ADDENDUM NO. 1
PROJECT MANUAL
HUNTSVILLE MUNICIPAL AIRPORT
CITY OF HUNTSVILLE, TEXAS
2025 AIRPORT RUNWAY PAVEMENT IMPROVEMENTS
TXDOT CSJ NO. 2517HUNTS

This Addendum to the Bid Documents is issued to modify, explain, or correct the original Contract Documents and Specifications for Huntsville Municipal Airport 2025 Airport Runway Pavement Improvements (TxDOT CSJ. No. 2517HUNTS) and is hereby made part of the Contract Documents. Acknowledgment of receipt of this addendum is required on the signature page of the Bid Form. Failure to acknowledge all addenda could render your Bid out of form and result in a non-responsive Bid.

Minutes
 Nonmandatory Prebid Conference
 2025 Airport Runway Pavement Improvements
 TxDOT CSJ No. 2517HUNTS
 City of Huntsville, Texas
 August 6, 2025, 9 A.M.

PHASING PLAN - RW CLOSED
HUNTSVILLE, TEXAS
HUNTSVILLE MUNICIPAL AIRPORT
2025 AIRPORT RUNWAY PAVEMENT IMPROVEMENTS

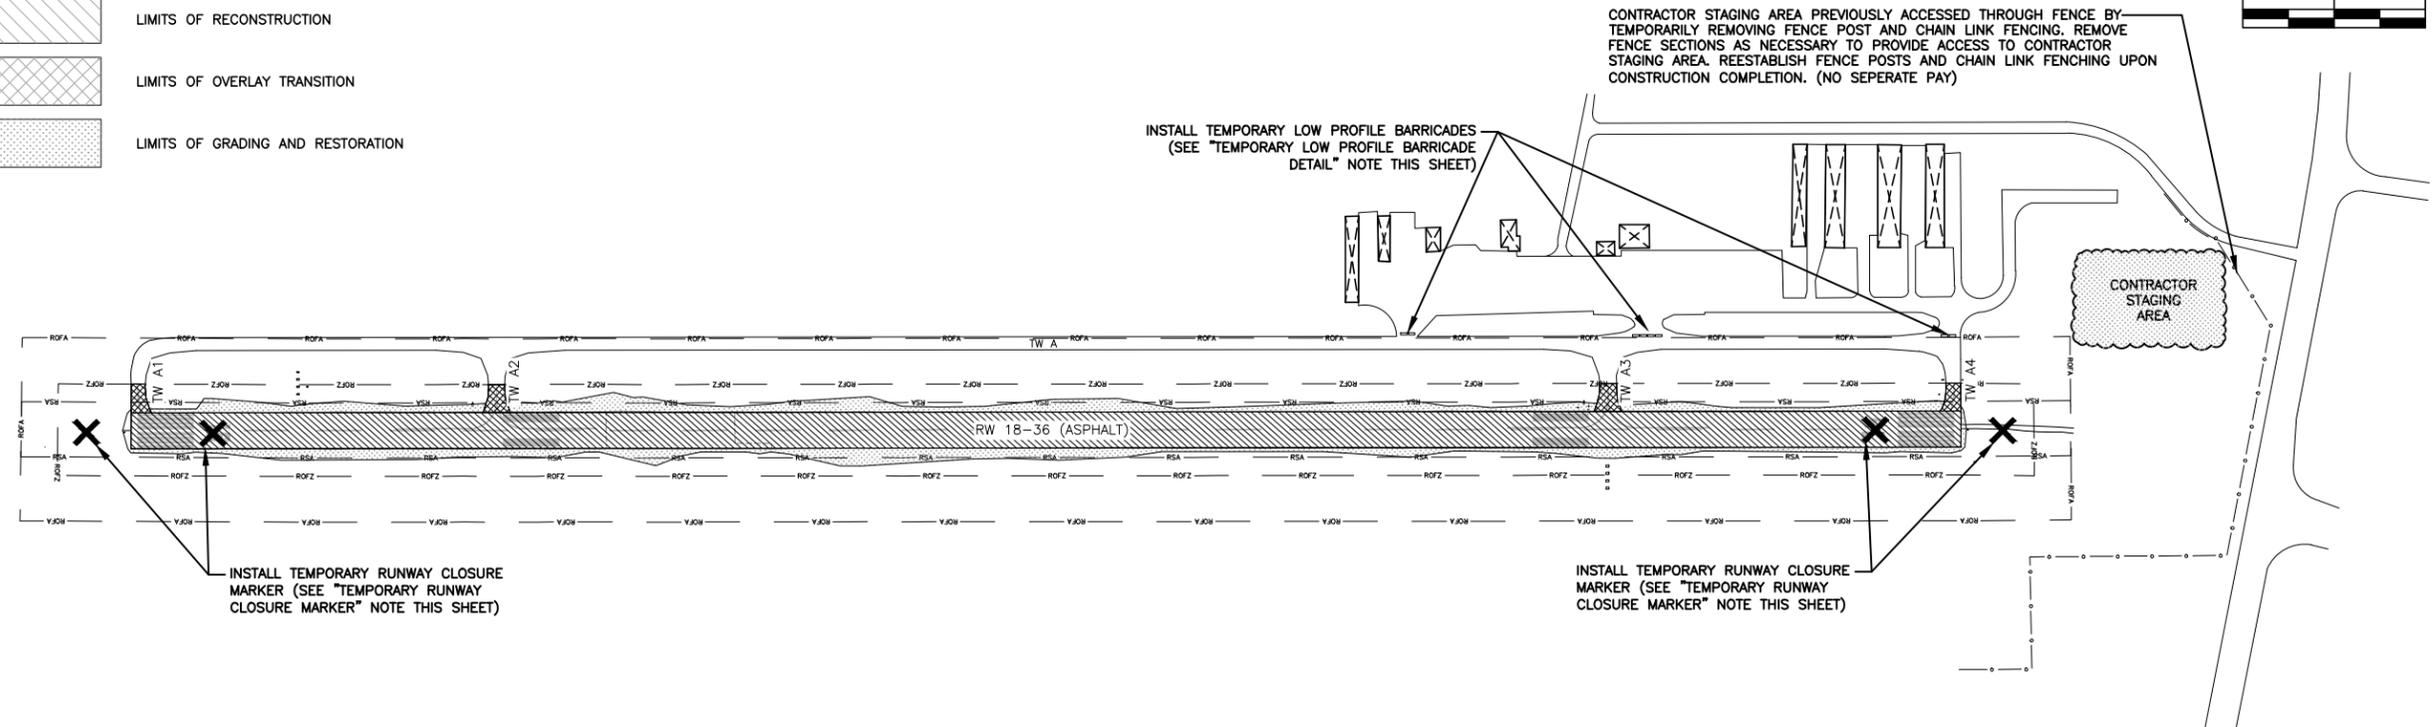
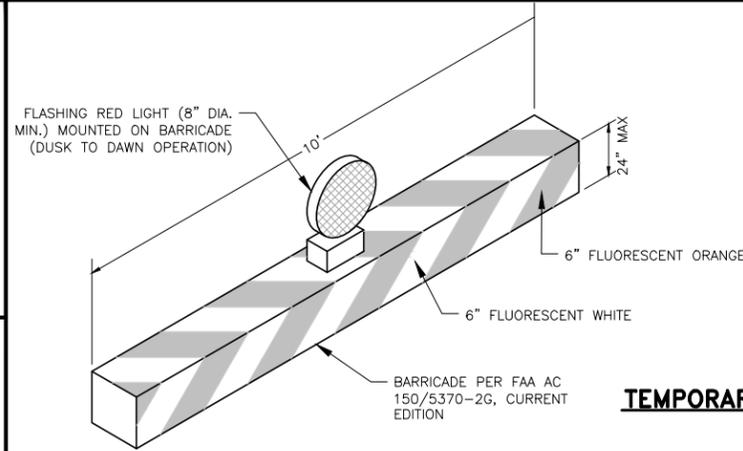
- i. Knife River (Lonnie) asked whether the RW will be shut down through the duration of the project? Engineer (Jared) stated that this will be clarified in Addendum No. 1.

1. DE-ENERGIZE RW 18-36 MIRLS, PAPIs, AND CLOSE RW 18-36. ALL PAVEMENT OUTSIDE THE ROFA TO REMAIN OPEN DURING CONSTRUCTION ACTIVITIES.
2. INSTALL TEMPORARY SEDIMENT CONTROL DEVICES, AS NECESSARY.
3. RECONSTRUCT RW 18-36.
4. PERFORM OVERLAY TRANSITION AT STUB TWS.
5. CONSTRUCT 1.5" PAVEMENT EDGE DROP-OFF AND PERFORM GRADING.
6. ESTABLISH SODDING AND SEEDING.
7. COMPLETE STRIPING AND RETROREFLECTORS.
8. CONTINUE WATERING SEEDED AREAS TO ESTABLISH VEGETATIVE GROWTH AS NEEDED DURING RUNWAY CLOSURE.
9. REOPEN RW 18-36 AND RE-ENERGIZE RW 18-36 MIRL AND PAPIs.

TYPICAL PAVEMENT SECTION
NTS

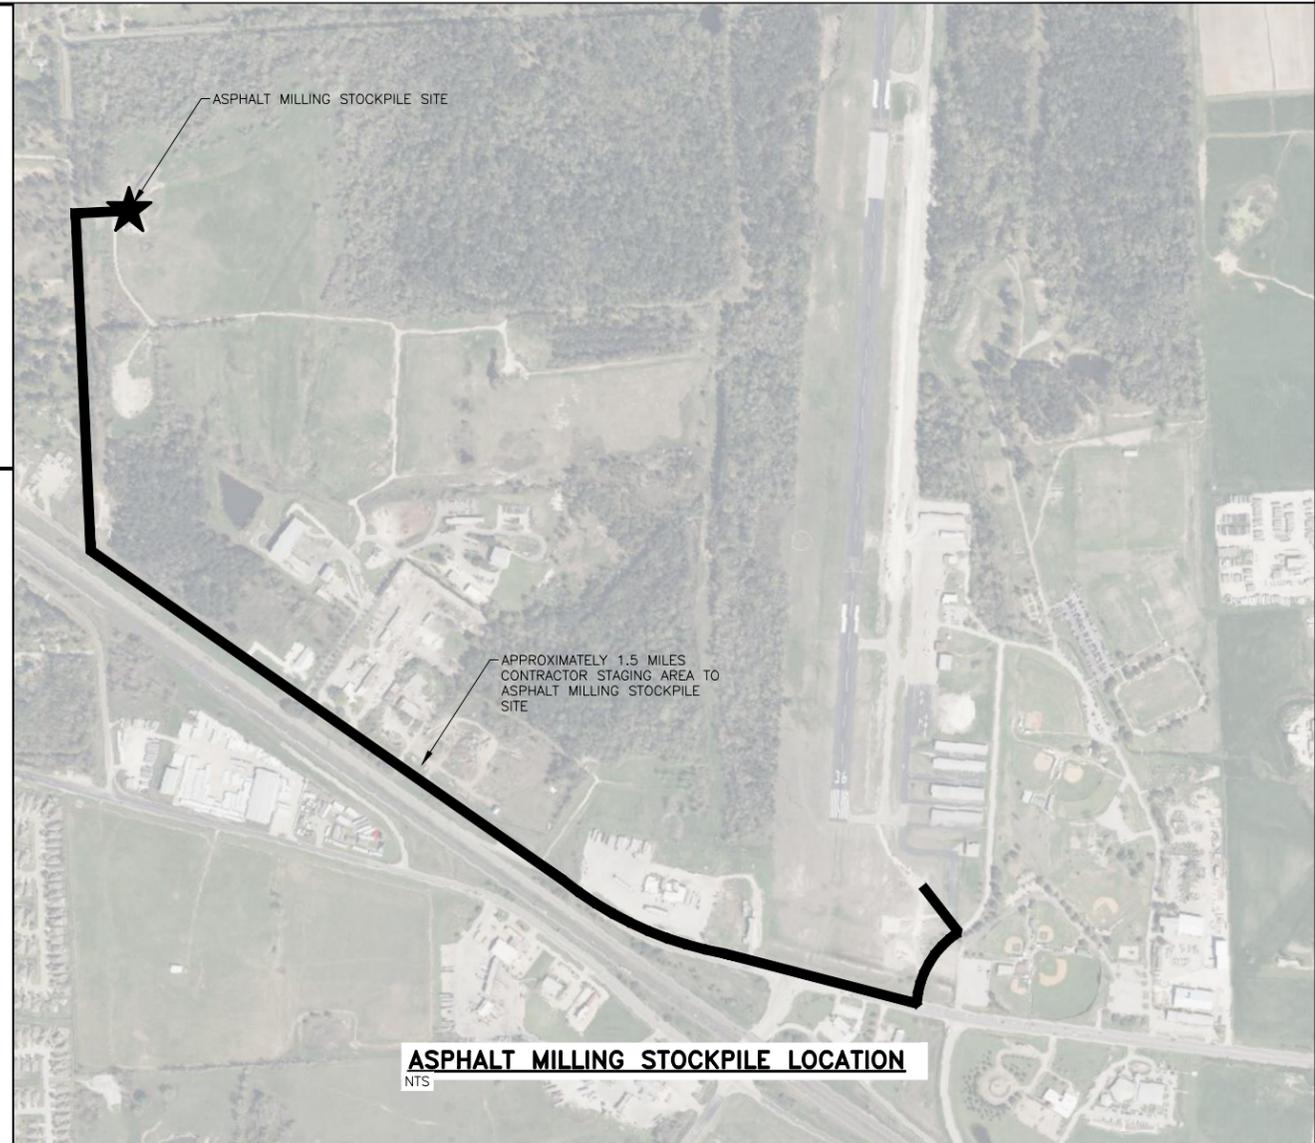
- c. Knife River (Lonnie) asked whether Grade 1-2 flexible base acceptable instead of Grade 3? Engineer (Jared) stated that this will be clarified in Addendum No. 1.

- e. Knife River (Lonnie) asked whether the 30 percent recycled asphalt pavement (RAP) is by weight or by volume? Engineer (Jared) stated that this will be clarified in Addendum No. 1.

*CEMENT STABILIZED BASE PER TxDOT ITEM 275. INCLUDE 1-INCH (TYP.) FLEXIBLE BASE PER TxDOT ITEM 247 (BASE BID). 6-INCH CEMENT STABILIZED BASE WITHOUT FLEXIBLE BASE (DEDUCTIVE BID ALTERNATE 1).

ASPHALT MILLING STOCKPILE LOCATION
NTS

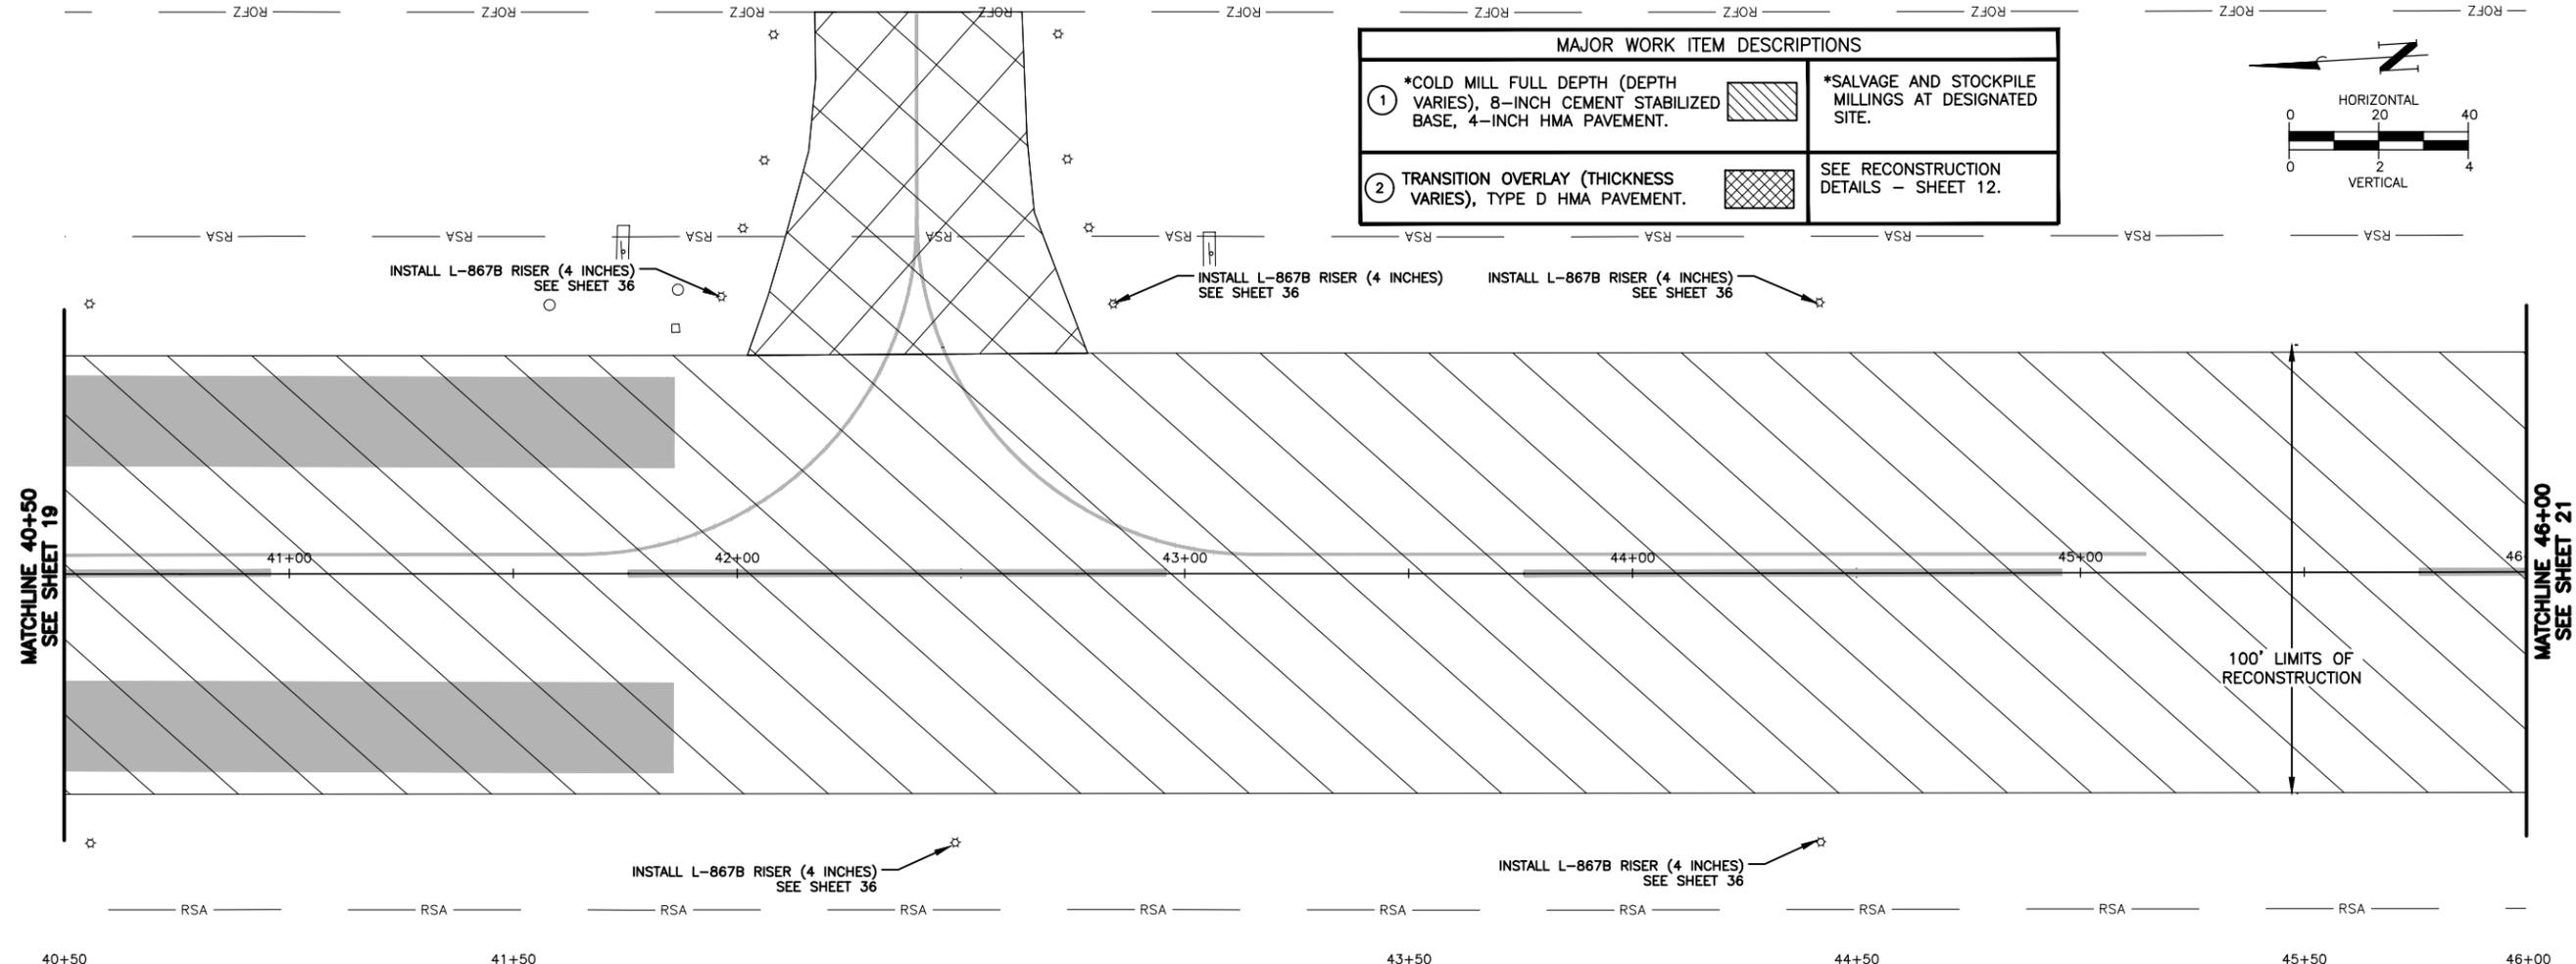
- d. Knife River (Lonnie) asked whether it is the intention to remove all hot mix asphalt regardless of the depth and deliver the excess to Owner's designated area? Engineer (Jared) stated that this will be clarified in Addendum No. 1.

11. PLACE TOPSOIL AS SHOWN. FIELD ADJUST AS NECESSARY TO MEET GRADES AND DROP-OFF REQUIREMENT. DO NOT IMPACT LIGHTS.
12. IN ACCORDANCE WITH THE "PROJECT GENERAL NOTES," EXCAVATED OR DEMOLISHED MATERIALS UNSUITABLE FOR INCORPORATION INTO THE FINISHED PROJECT SHALL BE DISPOSED OF OFF-SITE BY THE CONTRACTOR. ALL COSTS ASSOCIATED WITH THESE ACTIVITIES SHALL BE CONSIDERED SUBSIDIARY TO RELATED ITEMS OF EXCAVATION WORK. ASPHALT MILLINGS ARE TO BE STOCKPILED AT THE OFFSITE LOCATION. ASPHALT MILLING DISPOSAL AREA IS SHOWN ON SHEET 12.
